Remarks

U.S.S.N. 10,723,072

Replacement Sheet
67,200-1178

Figure 1F

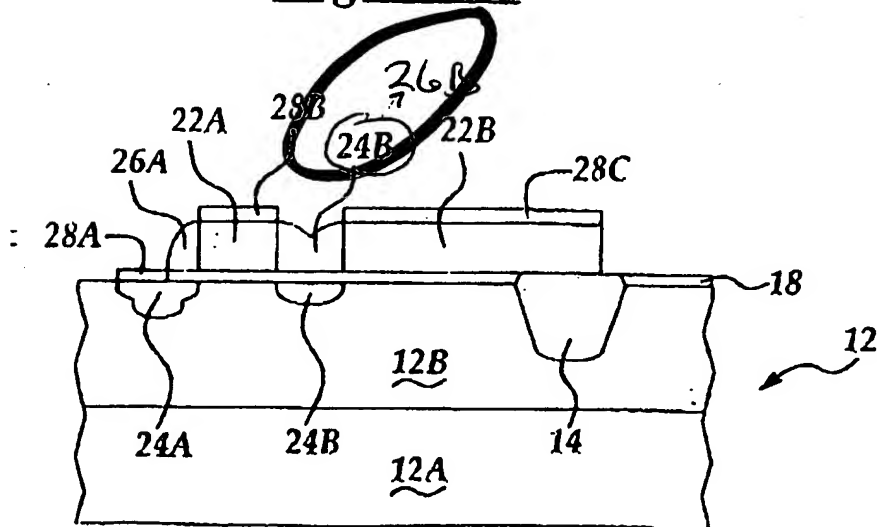
The drawings have been amended and a proposed replacement sheet submitted to correct "24B" to "26B" in Figure 1F to make it consistent with Figure 1E and the Specification.

Please replace "24B" in Figure 1F, pointing to a dielectric portion between pass transistor 22A and storage capacitor 22B, with "26B" to make Figure 1F consistent with the Specification and with Figure 1E.
